Publication 72M  
June 2010 Edition  
Change No. 1

**Standards for Roadway Construction, RC 1M-100M  
June 2010 Edition  
Change No. 1**

STANDARDS FOR ROADWAY CONSTRUCTION  
SERIES RC-1M TO 100M

PDT Pub #72M

NEW CONSTRUCTION OR  
ALTERATION DETAILS  
TYPE 6 CURB RAMPS

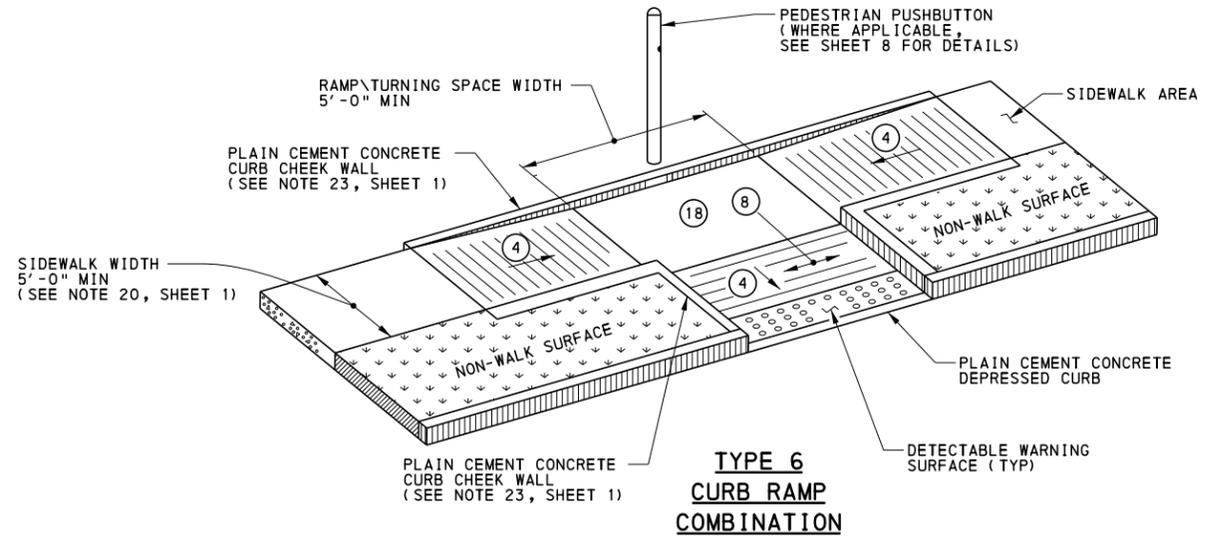
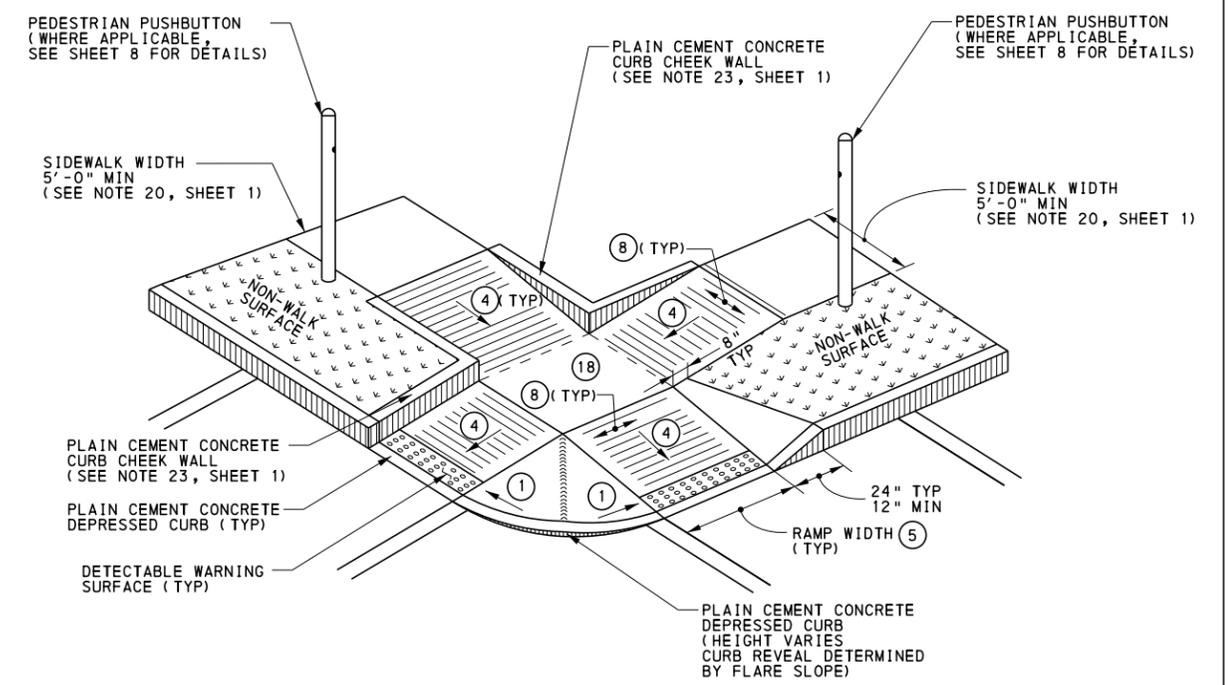
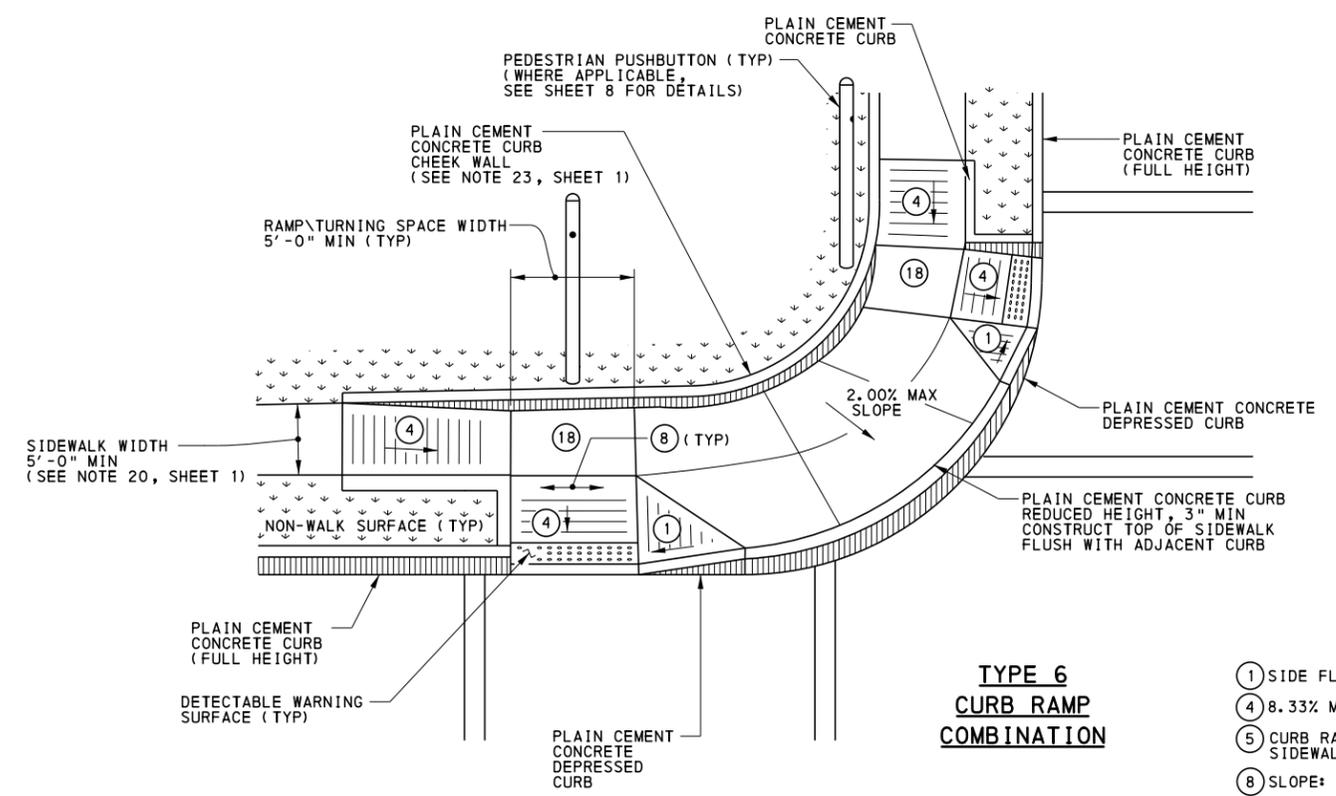
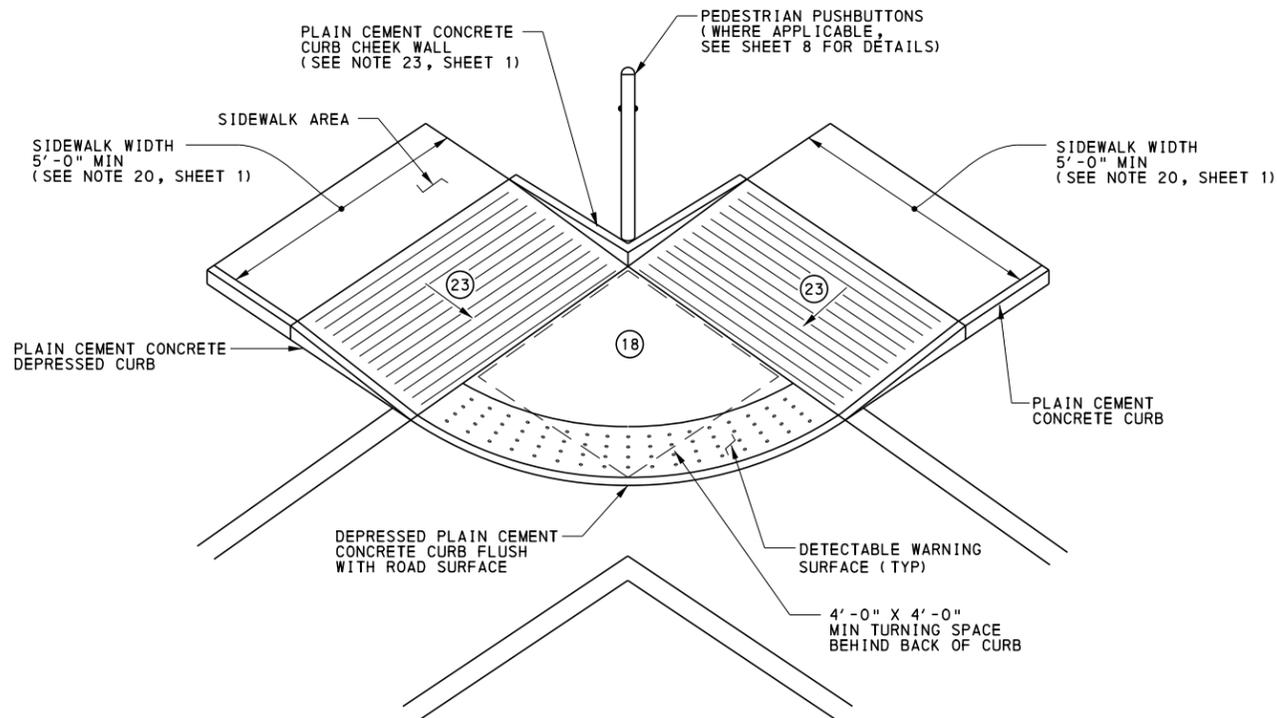
RC-67M	Sheet 5	<p>Modified Notes 4 and 18.</p> <p>Removed "AND TYPICAL ELEVATIONS" from title.</p> <p>For Type 6 Curb Ramp Combination details, relocated the pedestrian pushbuttons to a location in the non-walk surface that is outside of the sidewalk width and curb.</p> <p>For Type 6 Curb Ramps with Shared Turning Space detail, moved pedestrian pushbuttons farther away from ramp slopes.</p>
RC-67M	Sheet 6	<p>Modified Notes 4 and 18.</p> <p>For Blended Transition detail:</p> <ul style="list-style-type: none"> <li>*Moved crosswalk pavement marking from within the detectable warning surface to the outside of the detectable warning surface.</li> <li>*Changed "PLAIN CEMENT CONCRETE" to "PLAIN CEMENT CONCRETE CURB".</li> </ul>

NEW CONSTRUCTION OR  
ALTERATION DETAILS  
BLENDING TRANSITION / MEDIANS

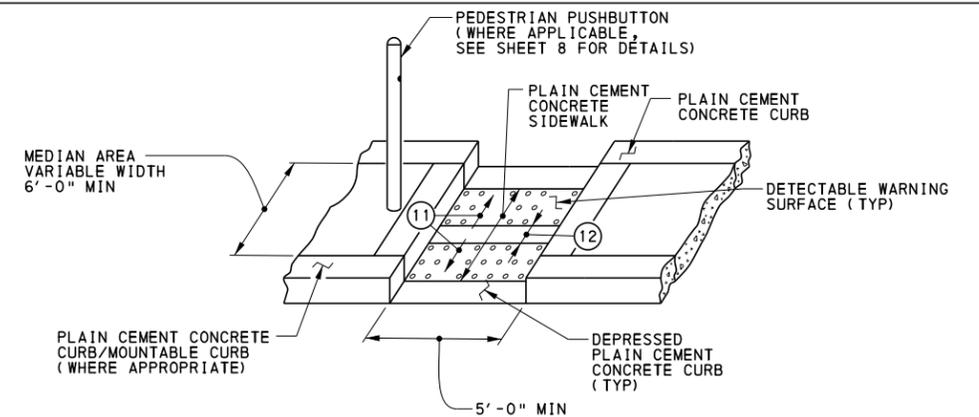
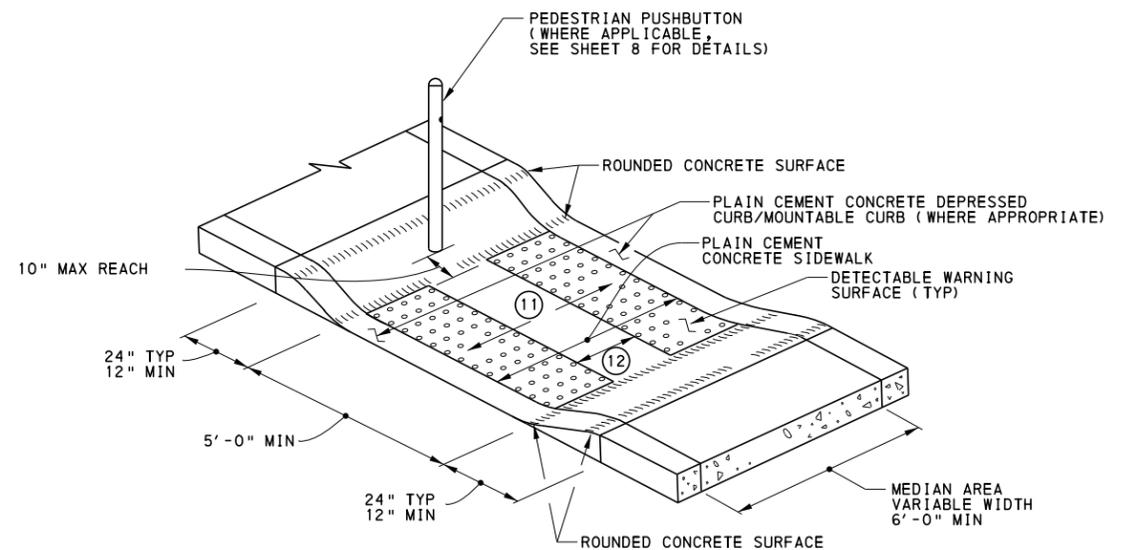
For Type A Typical Median or Island Access Opening with Curb Sides detail and Type B Typical Median or Island Access Opening with Flared Sides detail:

\*Deleted "FOR ALTERATIONS MAX EXTENT FEASIBLE 4'-0" MIN".

\*Added "/MOUNTABLE CURB (WHERE APPROPRIATE)" with "PLAIN CEMENT CONCRETE CURB" and "PLAIN CEMENT CONCRETE DEPRESSED CURB".

\*Revised dimension line for variable width of the median area to exclude the curb.

Modified Notes 12 and 18.

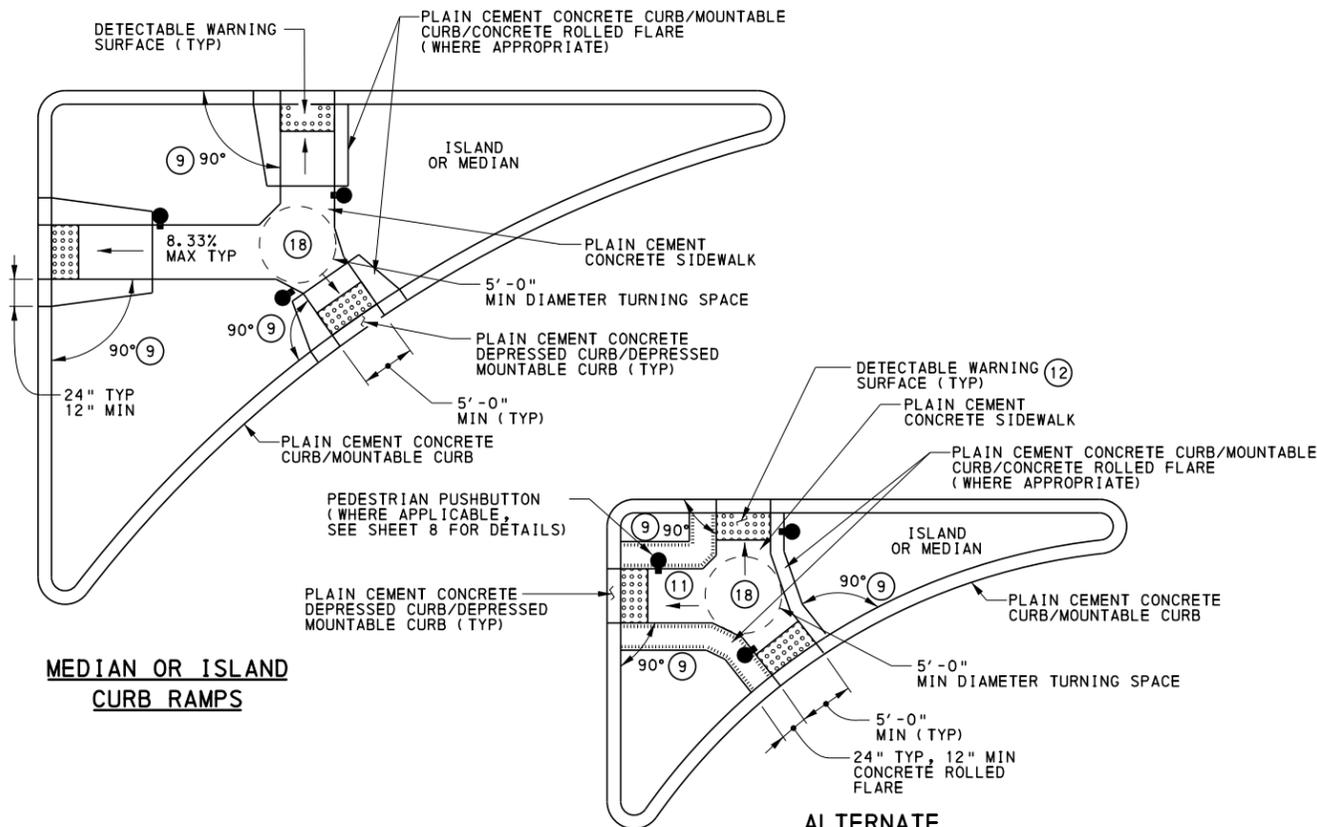
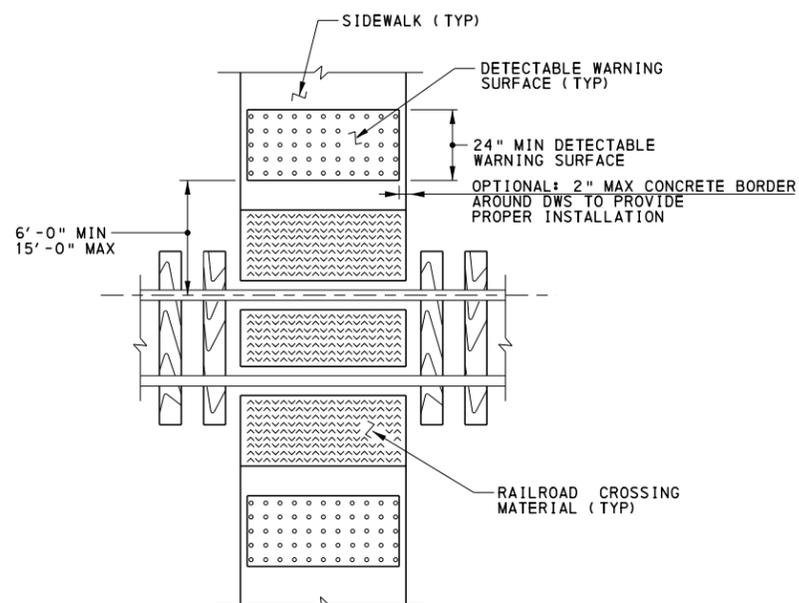
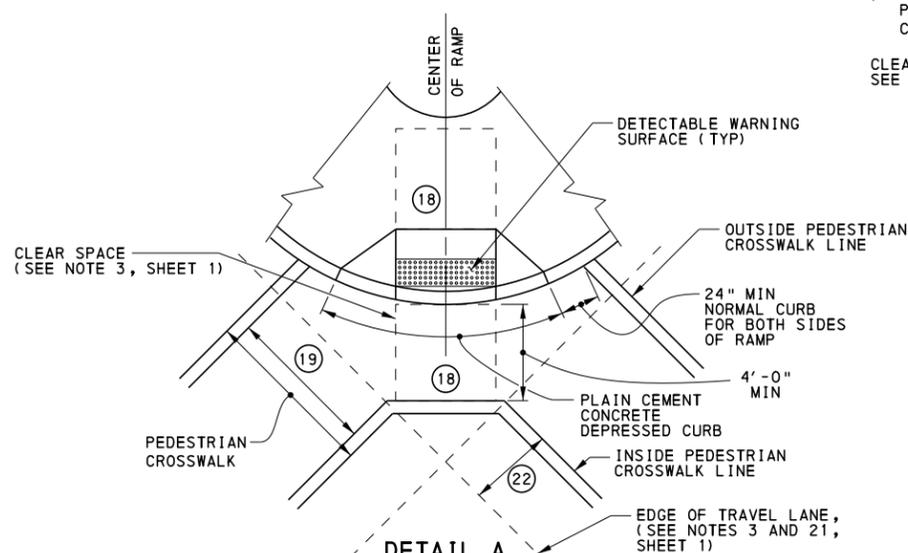
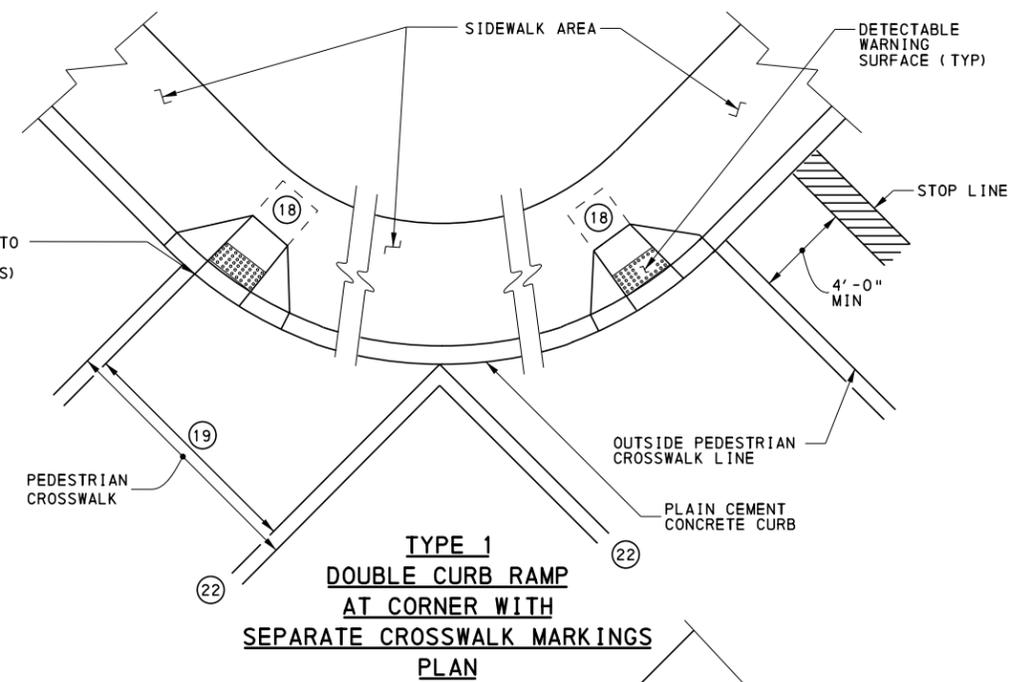
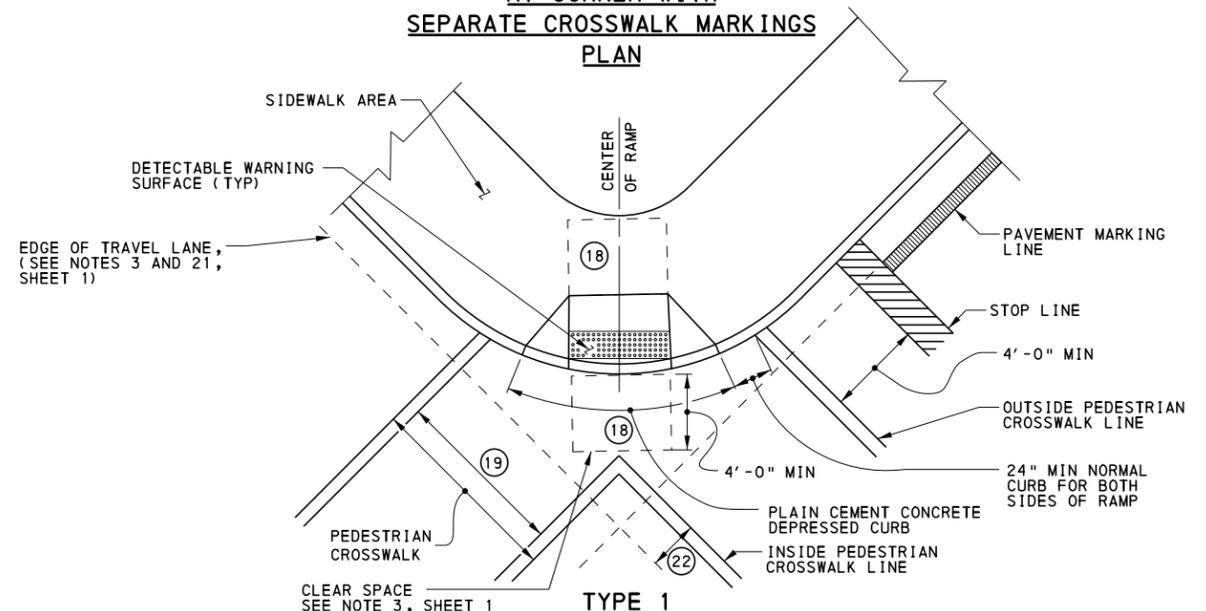
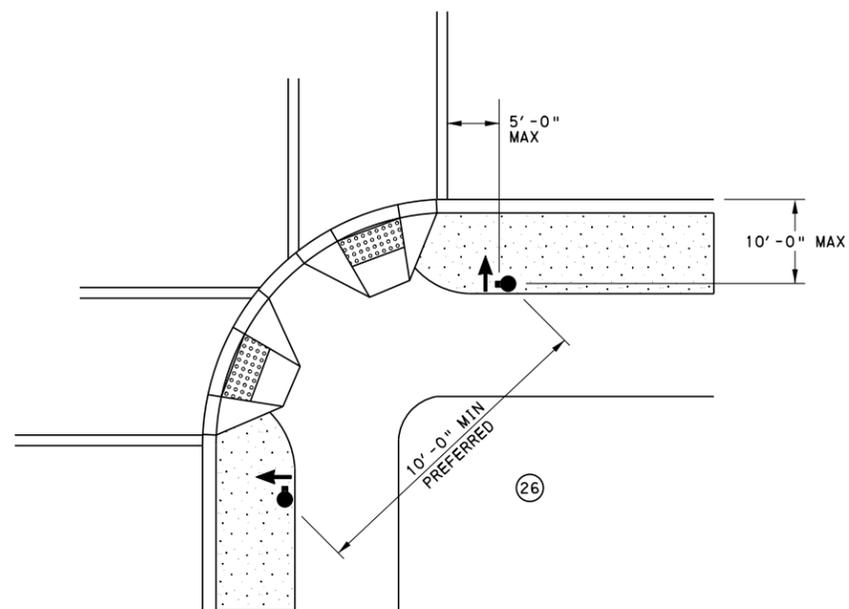
RC-67M

Sheet 7

For Median or Island Curb Ramps detail and Alternate Small Island with Cut Through detail:

\*Added references to mountable curbs and concrete rolled flares.

\*Added width dimensions of 24" TYP, 12" MIN for concrete rolled flares.

For Alternate Small Island with Cut Through detail, added Note 12 after "DETECTABLE WARNING SURFACE (TYP)".

For Type 1 Single Curb Ramp detail, relocated Note 22 to indicate width from inside pedestrian crosswalk line to edge of travel lane.

For Typical Detectable Warning Surface at Railroad Crossing detail:

\*Revised graphic to indicate distance of 6'-0" MIN to 15'-0" MAX from the center of the closest rail to the nearest edge of the detectable warning surface.

\*Added "OPTIONAL: 2" MAX CONCRETE BORDER AROUND DWS TO PROVIDE PROPER INSTALLATION".

For Detail A detail:

\*Modified detectable warning surface to appear as a completely rectangular shape.

\*Relocated Note 22 to indicate width from inside pedestrian crosswalk line to edge of travel lane.

Added Note 12.

Modified Notes 18 and 22.
